Case #2010-COA-296 (CAMA):

To approve a Certificate of Appropriateness to:

Staff Reviewer: Ann Steadham

Front of Building

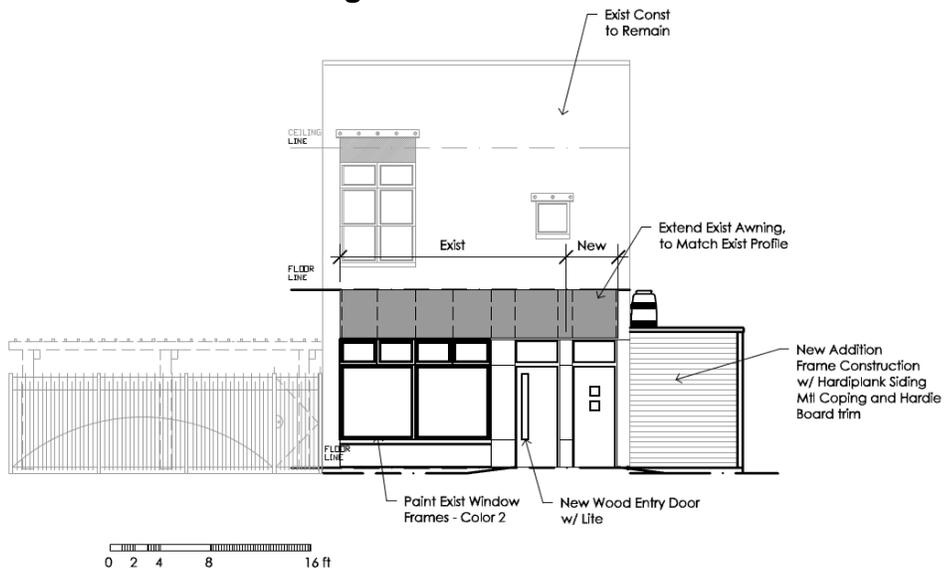
The existing awning on the front of the building would be lengthened and a new black fabric covering would be installed over the existing frame. An existing opening on the Mass Ave side of the building would receive a new framed set of infill panels with a set of three glass transom windows above. On the interstate side of the building, the request includes the construction of an addition to the building. An enclosed dumpster area is proposed closest to the rear alley adjacent to the new addition. Directly above the dumpster area, the applicant would like to install a commercial grade round exhaust fan for the kitchen. Also, the applicant is proposing to provide rain barrels on a shelf mounted high on the wall above the dumpster area. Staff considers the modifications to the front and Mass Ave side of the building to be appropriate for this building. The additions to the interstate side of the building are focused on below.

4. Awnings shall be of fabric construction on metal frames. High-sheen finishes are not permitted.
5. Awning supports and hardware must be installed using methods which cause as little damage as possible to the exterior walls. Fasteners at masonry locations should be installed in the mortar joints. Do not drill into or otherwise damage masonry (brick, block, structural tile, etc.).

**Side of building facing towards Cultural Trail
(side most visible from Bellefontaine St and Massachusetts Ave)**

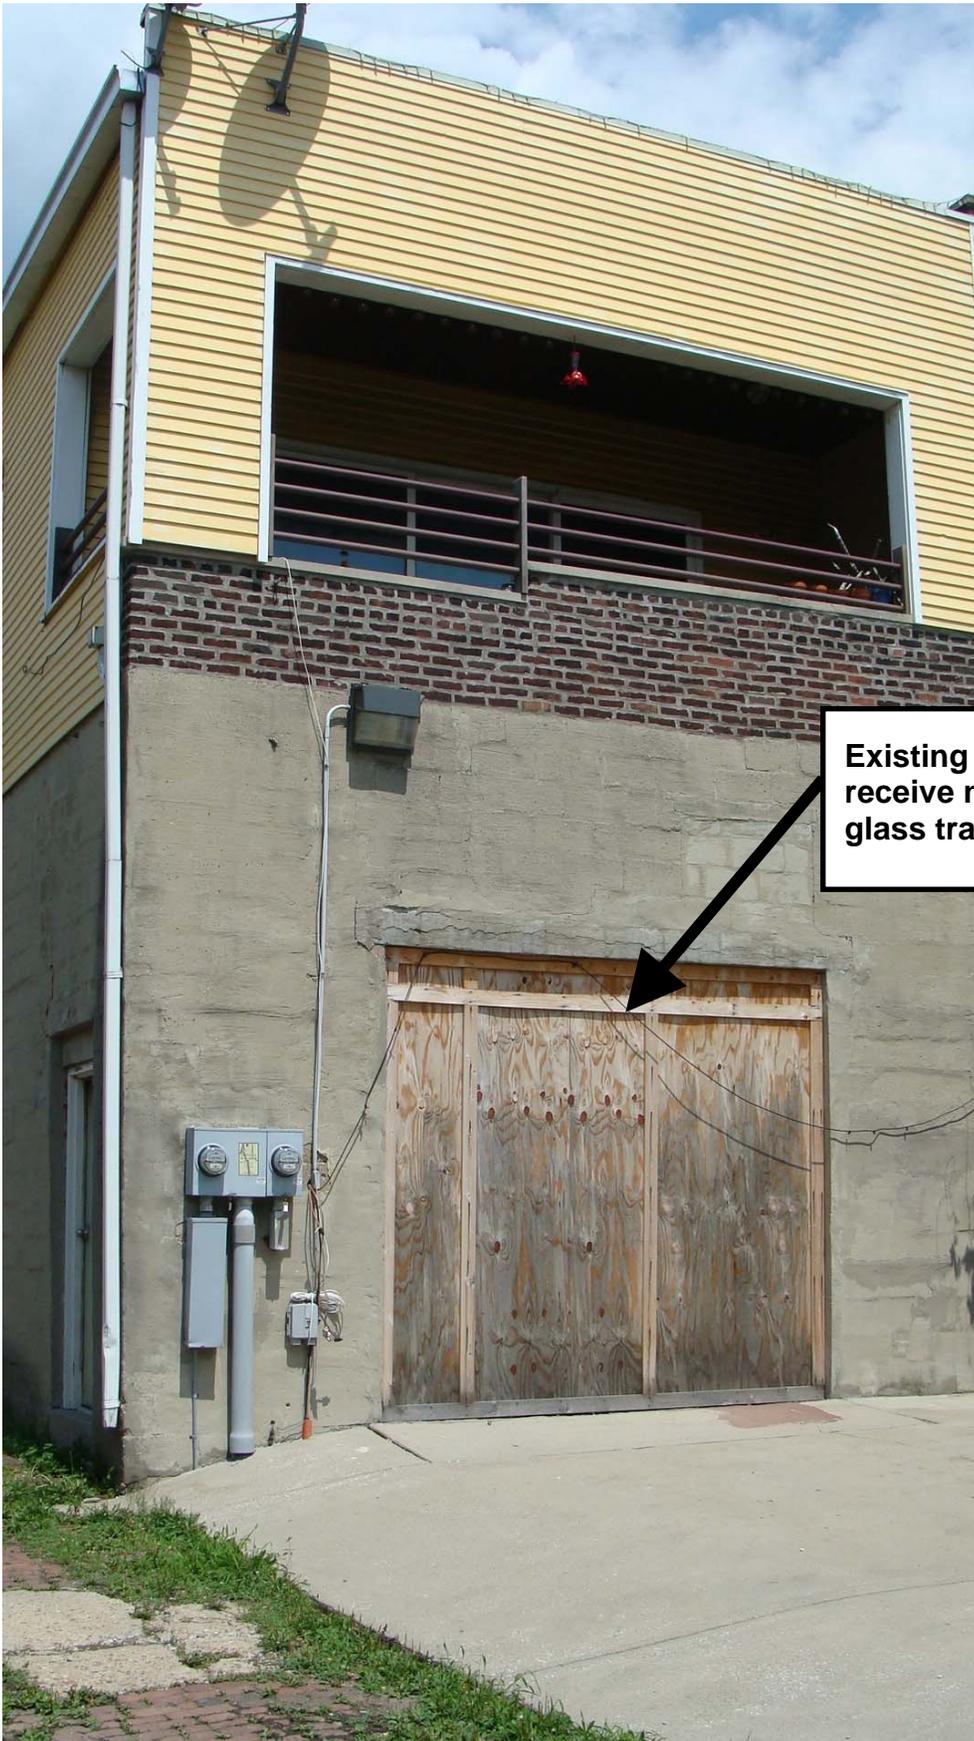
Existing first floor opening to receive new infill panels with a glass transom area above

6. Signage is not permitted by this certificate. Any text, numerals, logos, or other signage will require a separate certificate.
7. New windows must fit the existing openings; altering existing openings is NOT permitted.

8. All new windows shall match the dimensions, style, profile, and material of the existing; this includes components such as stiles, rails, muntins, casings, jambs, and sills.

Side of building facing interstate

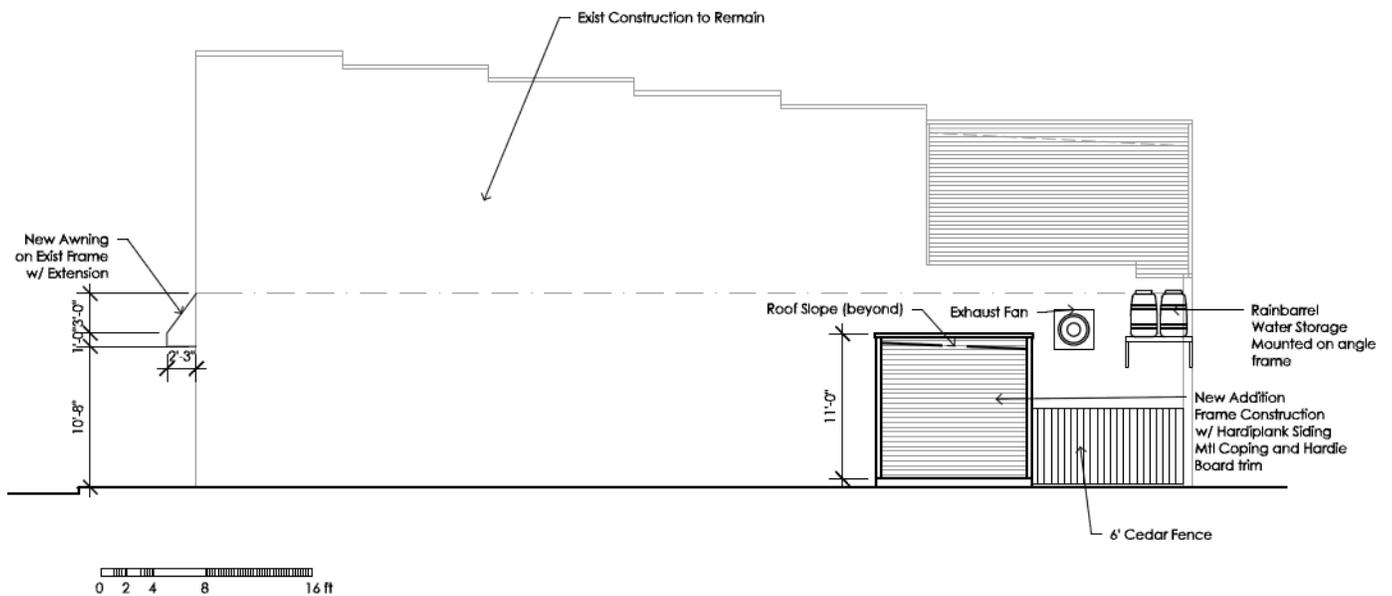
The applicant is proposing to put all of the major restaurant components needed on the interstate side of the building. The proposed addition on the interstate side of the building would house a pre-fabricated cooler unit installed on a concrete slab on grade. The property owner's architect designed a simple enclosure that attaches to the side of the building in the open area facing the interstate. A door opening would need to be cut through the first floor of the rear block wall addition to provide access from the interior. The proposed addition would have a fiber cement lap siding with corner trim boards and a simple flat roof sloped for drainage. The top edge of the addition would be capped with a metal coping. A simple edge guttering system would run along the back side of the addition.

Area of building to receive proposed addition

9. Siding and trim materials must be wood or cementitious board and must have a smooth texture free of major imperfections and without embossed grain or rough-cut texture; artificial wood-grain patterns are NOT permitted. Siding exposure shall match the siding found on the primary structure.
